# Access Compliance Report

## Public Rights-of-Way

Intersection ID: 29459	Main Street: N_ALEXANDER_ST	Cross Street: GARDEN_DISTRICT_DR	Location: W
ADA ID: BB2A9D9FAE08	Ramp Type: PerpDiag	Initial Pass/Fail: Fail	Overall Compliance: No
Severity Score: 33.75			
Codes/Mitigation Info/Possible Solution		Field Measurements/Component Compliance

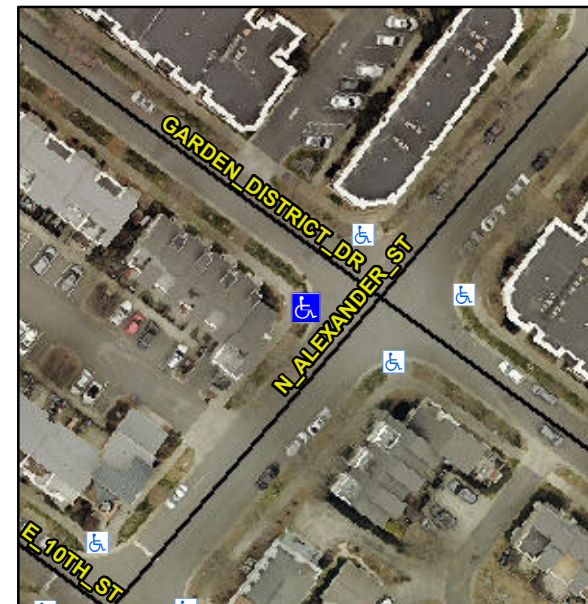
Compliance	Description	Data	Compliance	Description	Data
N/A	Ramp Length (in)	75.0	Yes	Ramp Slope (%)	7.0
No	Ramp Width (in)	36.0	No	Ramp XSlope (%)	8.7
N/A	Flare Type LT	N/A	N/A	Flare Type RT	N/A
N/A	Flare Slope LT (%)	N/A	N/A	Flare Slope RT (%)	N/A
N/A	Flare Traversable LT?	N/A	N/A	Flare Traversable RT?	N/A
N/A	Landing Length (in)	N/A	N/A	DWS Provided?	N/A
N/A	Landing Width (in)	N/A	N/A	DWS Contrast?	N/A
N/A	Landing Slope (%)	N/A	N/A	DWS Length (in)	N/A
N/A	Landing X Slope (%)	N/A	N/A	DWS Full Width?	N/A
N/A	Landing Curb? (Y/N)	N/A	N/A	DWS Offset (in)	N/A
N/A	Shared Landing?	N/A			
N/A	Gutter Ponding?	N/A	N/A	Gutter Slope (%)	N/A
N/A	Gutter Lip Ht (in)	N/A	N/A	Gutter X Slope (%)	N/A
N/A	Painted X Walk1?	No	N/A	Painted X Walk2?	No
	X Walk 1 Direction	To SE		X Walk 2 Direction	To NE
N/A	X Walk 1 Width (in)	N/A	N/A	X Walk 2 Width (in)	N/A
	X Walk 1 Slope (%)	3.1		X Walk 2 Slope (%)	3.0
	X Walk 1 X Slope (%)	5.1		X Walk 2 X Slope (%)	4.1

N/A	Ramp inside XWalk1?	N/A	N/A	Ramp inside XWalk2?	N/A
	Road Slope (%)	6.4	N/A	Clear Space?	N/A
	Road X Slope (%)	0.4	N/A	Clear Space to XWalk (in)	N/A
N/A	Any Obstructions?	N/A	N/A	Storm Grate/Utility Hazard?	N/A
	Obstruction Type			Storm Grate/Utility Type	
		N/A			N/A
			Yes	Surface Condition? (G/P)	Good

**Remove & Replace Curb Ramp With Two New Directional Ramps or Equivalent.**
